Wulfsberg Electronics <i>A Chelton Group Company</i>		
APPROVALS				DATE
DRAWN	V. Wallace	06/05/03		TITLE: SERVICE BULLETIN WSB C-5000-12 CONVERSION TO EXTERNAL DES ENCRYPTION
CHECKED	C. Estes	06/10/03		
PRODUCT MANAGER	S. Hovelsrud	06/10/03		
ENGINEER	G. Hayes	06/10/03		
ISSUED	V. Wallace	06/11/03		SIZE A
		CAGE CODE 1B7G3	DWG NO. 150-042962	REV B
Typed signatures indicate approval. Handwritten signature approval of this document is on file at Wulfsberg Electronics, Prescott, Arizona.		SCALE: NONE		DO NOT SCALE DRAWING

BULLETIN NUMBER: WSB C-5000-12 Revision B

This is an upgrade to a digital capable control head with external DES (Red/Green) encryption.

DETAIL A

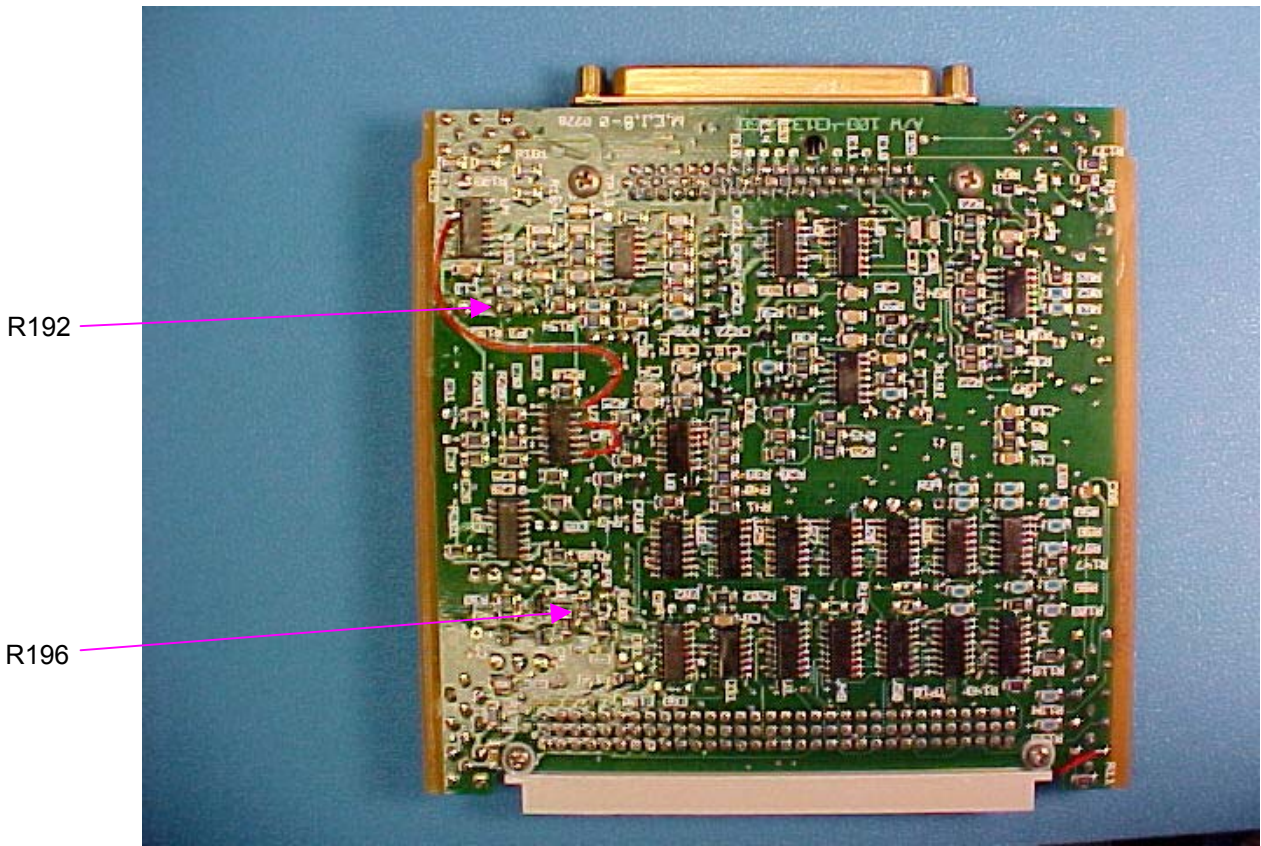
- A. For 300-031320-01 System Interface cards - to improve wideband audio response, reroute microphone audio, change key erase to active low configuration, and add +5V to microphone bias. (Refer to DETAIL A and DETAIL B).

1. Remove R187 from JP2 pads 1-2.
2. Remove the ALC module wire that is soldered to the R140 pad adjacent to R176.
3. Solder that wire on to JP2 (the center pad).

4. Remove R140. Located near JP2, TP15, CR27, and CR19 on component side.
5. Remove R187 from JP2 pads 1 & 2. Install item 1 (Resistor) onto JP2 pads 2 & 3. Located near TP15 on component side.

6. Verify or replace C70 with item 2 (Capacitor). Located near T1, U34, and CR34 on component side.
7. Add R110 using item 1 (Resistor). Located near center of 37 DSUB connector.
Note: This step should be skipped if Service Bulletin WSB 5000-5 is or will be installed. It replaces R110 with a short circuit protection device.

8. Verify R196 is moved from JP8 pads 1 and 2. Install item 1 (Resistor) onto JP8 pads 2 and 3. Located near E91, E81, R7, and R8 on solder side of board.

9. Remove R192 from JP3 pads 1 & 2. Install item 1 (Resistor) onto JP3 pads 2 & 3. Located near U4 on solder side.
10. Replace R172 with item 3 (Resistor). Located near U55 and TP12 on component side.

C70

R110

R187

R172
